Bridge Tech Committee – Design & Construction Subcommittee Meeting

2018-03-28

Bridge Technical Committee Structures Design & Construction Subcommittee

► Cast-In-Place Vertical Parapet Reinforcing Steel

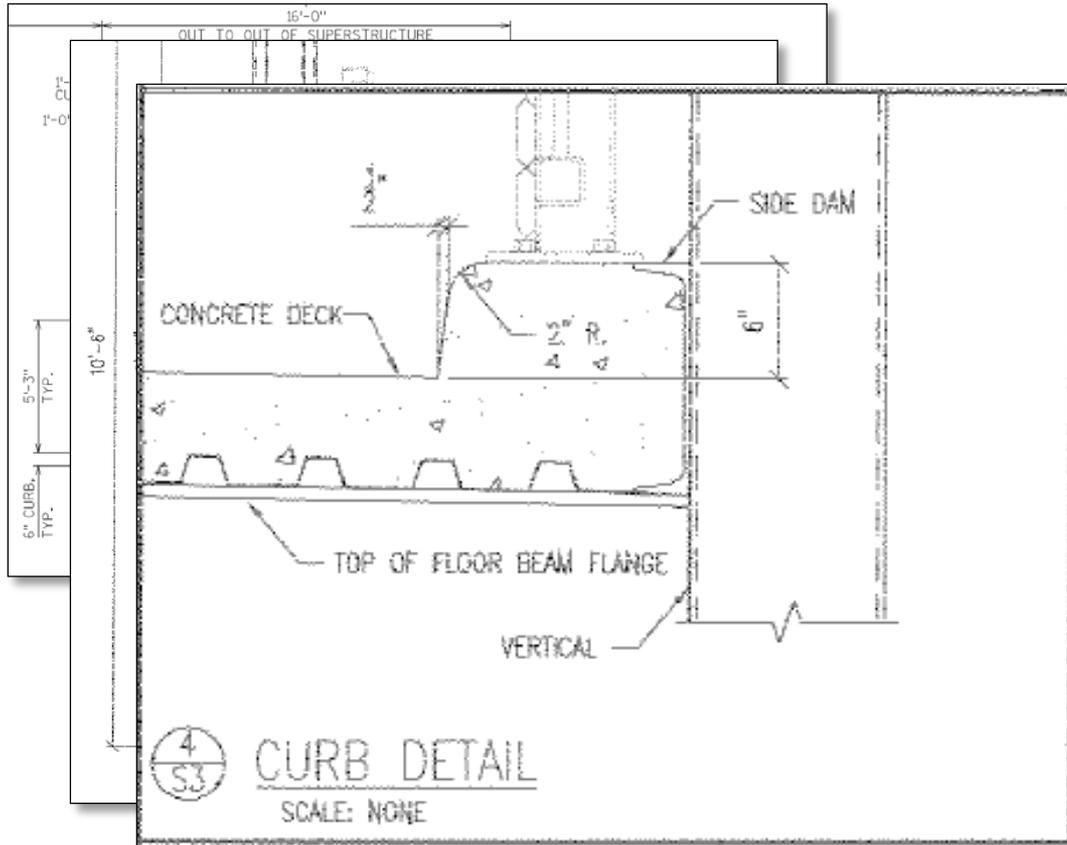
ITEM	DATE	DESCRIPTION	STATUS	DUE DATE	BALL IN COURT
1.14	3/21/16	<p>Cast-In-Place Parapet Reinforcing Steel</p> <p>Industry has expressed concerns that vertical face parapet bar steel extending out of deck causes issues with paving equipment during the deck pour. This is also an issue at wing locations. <i>BOS is currently working on updated Standard parapet reinforcing steel detailing and will provide guidance through the next update to the Bridge Manual.</i></p> <p>2016-07-19: BOS has updated a number of Standard Details to address this issue. The new Standards show two separate vertical reinforcing bars similar to the sloped face parapet details. These details will not be published at this time because of impending MASH crash testing criteria verification, but will allow a field change to be made upon request</p> <p>2017-03: BOS is continuing to work on refining the detail to avoid any conflicts and also is still assessing the MASH crash testing criteria. BOS plans on updating the Standard with the July 2017 Standards updates. Contractors may request to use modified reinforcing steel details on a project via RFI for projects that do not show the two-bar system.</p> <p>2018-03: BOS staff have created updated details and are working to verify that the use of two vertical bars in lieu of one will not cause other issues with railing attachments, etc. The updated details are likely to be published with the July 2018 updates to the Bridge Manual and soon thereafter should start showing up in contract plans. However, there may still be some outstanding MASH implementation issues that cause a delay in publishing these updates to Standards. If contractors would like to use two vertical bars in lieu of one as is detailed in current contract plans, they can submit an RFI to the project team and BOS would approve that change.</p>	Open	7/2016 7/2017 7/2018	WisDOT

Standards to be updated to change to two vertical bars in July 2018

▶ Pedestrian Bridge Curb Pours

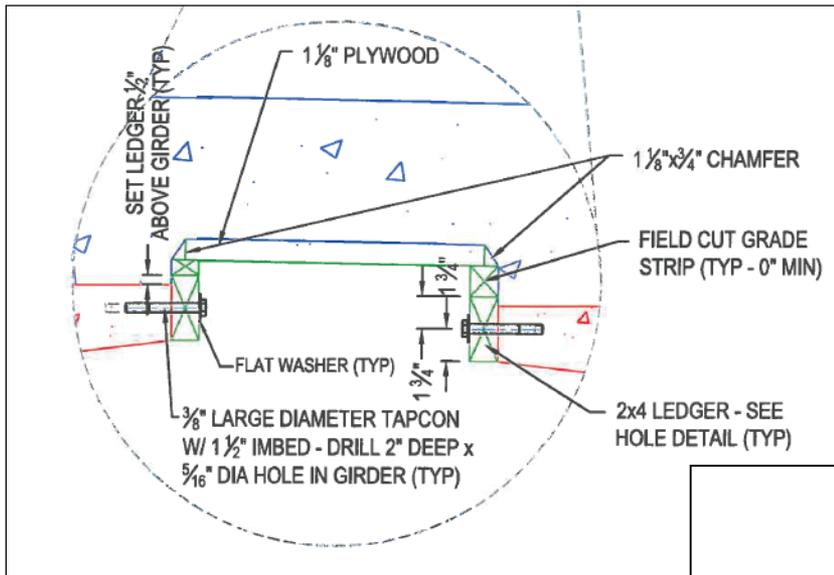
2018-03: Aaron Bonk stated that BOS still has concerns with placing a cold joint between the deck and curb due to the potential for chlorides and moisture to have access to the longitudinal stringers at the edge of deck (which are structural members on pedestrian truss bridges). If a contractor is awarded a prefabricated truss pedestrian bridge and wants to modify this detail, they can propose an alternative detail for review by BOS Design. BOS Design may be open to an alternative detail (waterstop, etc.) and will investigate if there is a way to insert language into the Standards to have designers allow monolithic or multiple pours with corrosion inhibiting elements.

Contractor to propose modifications to curb pours for review by BOS Design after prefabricated truss pedestrian bridge projects have been awarded

▶ Alternative Decking Systems for Prestressed Girder Bridges

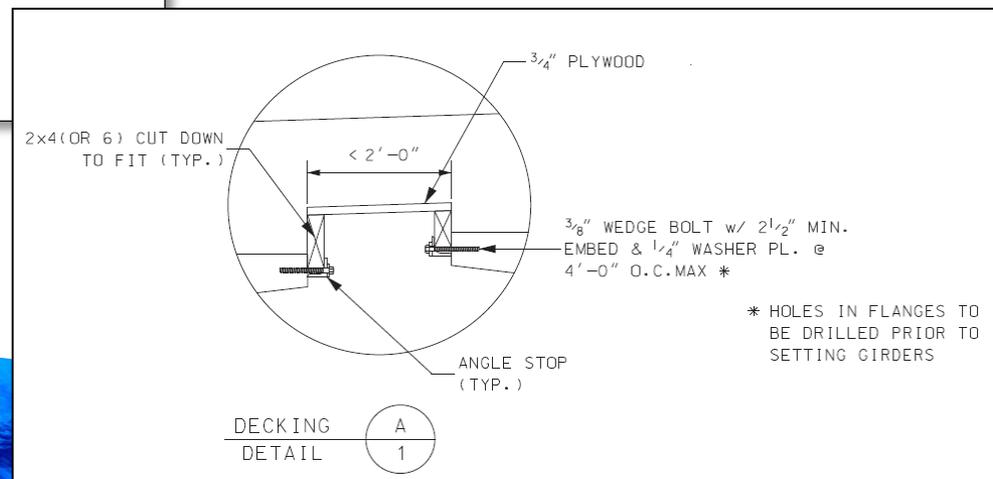
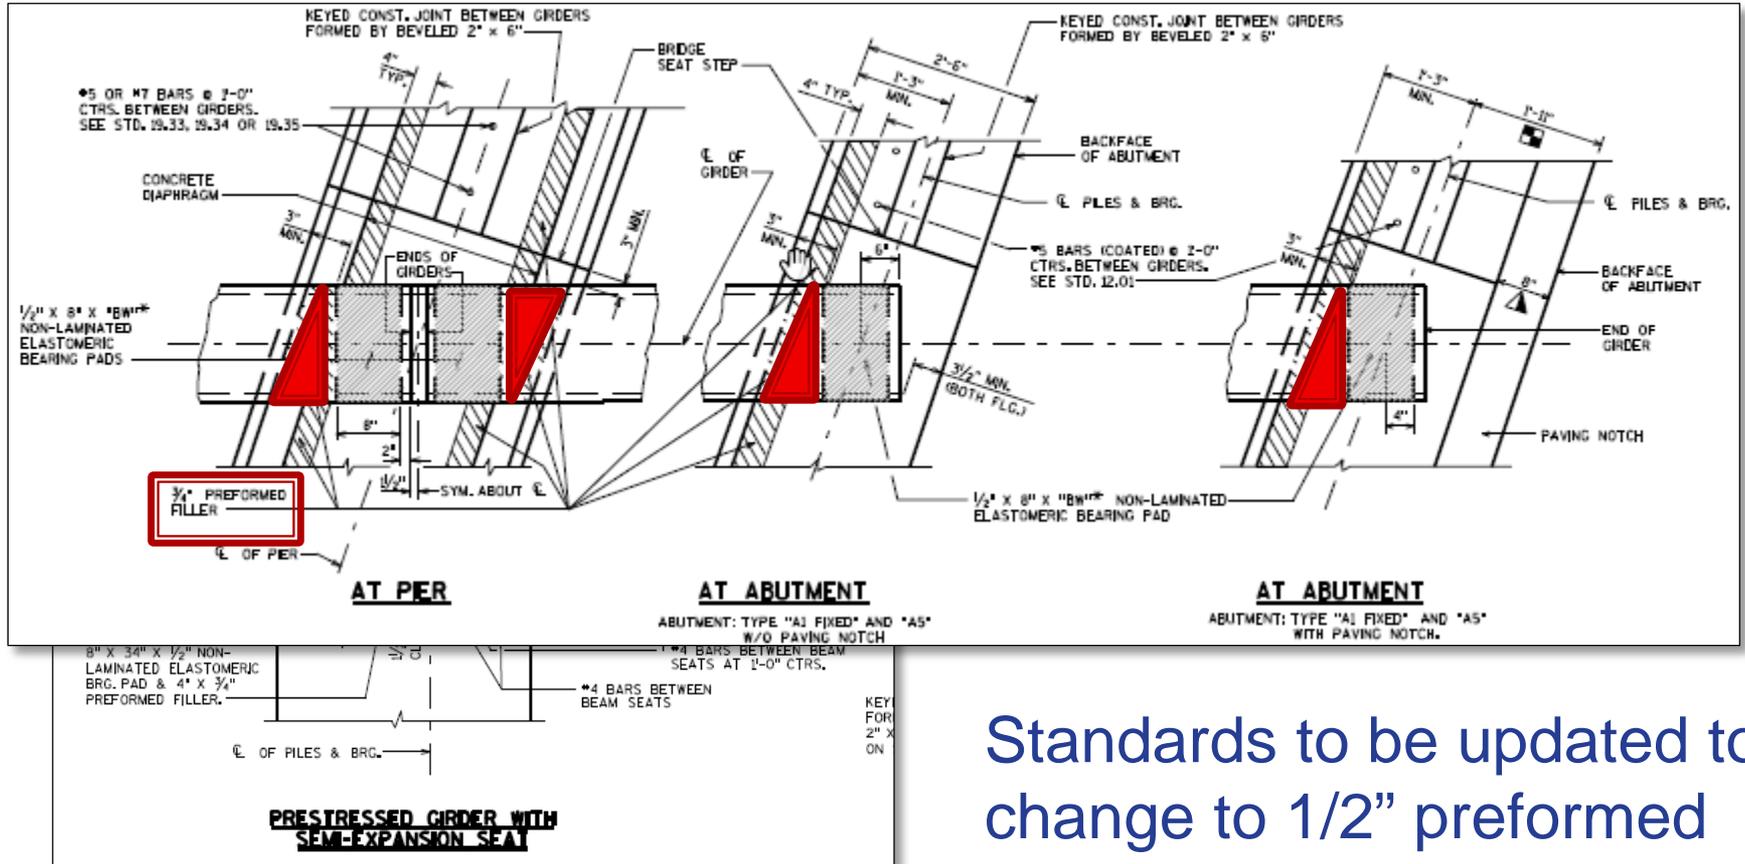
2018-03-28: Aaron Bonk stated that through reviews of bridges and their respective inspection reports, BOS has not identified specific problems or issues with the alternate forming systems. At this time, BOS will not be prohibiting the alternative systems from use but BOS

Details similar to those shown below will be allowed for use, but may be revisited if issues are found in the future

► Filler/Cork Material Under Girders

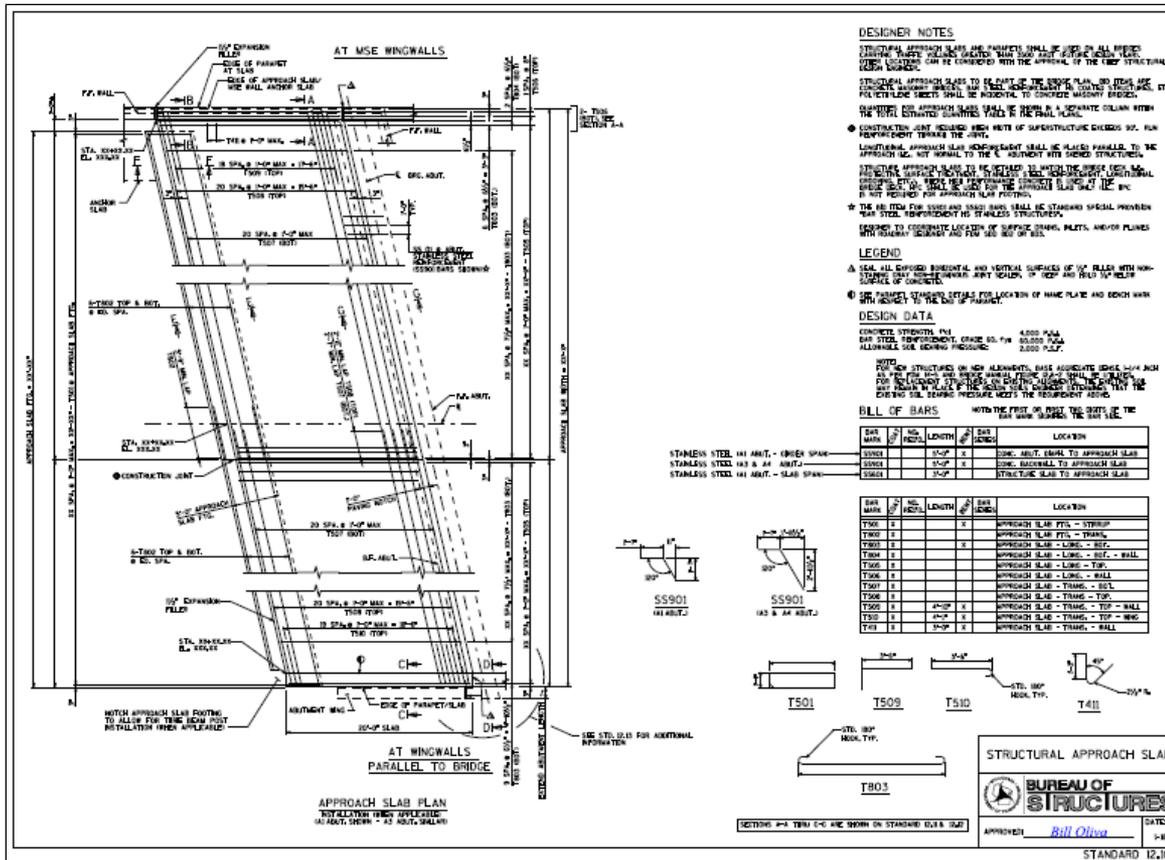
2018-03-28: At the November 29, 2017 Bridge Tech Committee Meeting it was decided that BOS would be revising our Standard Details (and subsequently contract plans) to utilize 1/2" preformed filler in lieu of 3/4". BOS staff reviewed the changes required based on this intent and was unable to get all of the changes incorporated into the January 2018 updates. These updates will be finalized with the July 2018 updates to the Bridge Manual.

Standards to be updated to change to 1/2" preformed filler in July 2018

Uniform Spacing of Rebar in CIP Retaining Walls

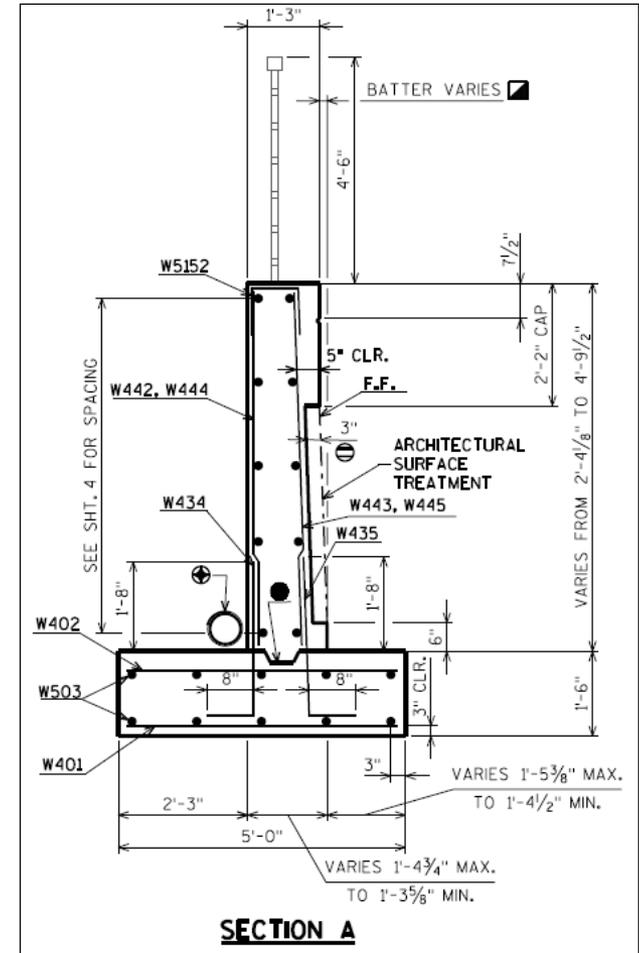
- ▶ Consistent horizontal bar spacing could improve labor and construction time
- ▶ Consistent footing step heights would also benefit construction time
- ▶ Very few walls of this type built each year throughout the state

Railing Post Base Plate Dimensions

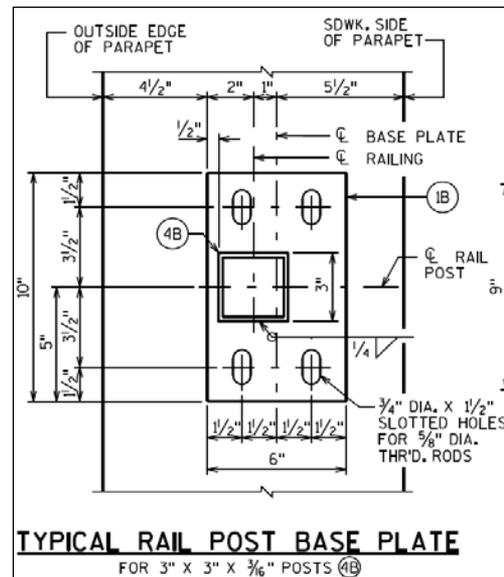
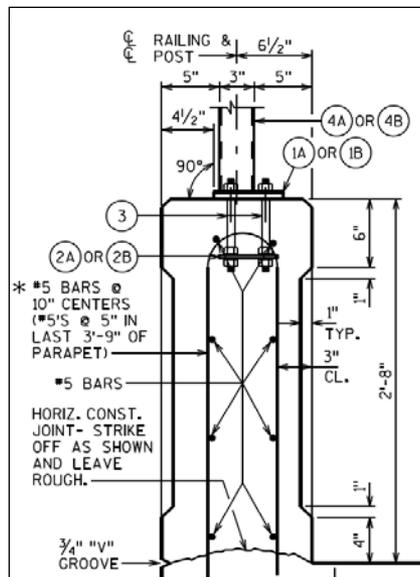
- ▶ Industry practice is to use adhesive anchors – current details have anchors vertically under horizontal rail members requiring the railing to be removed for drilling
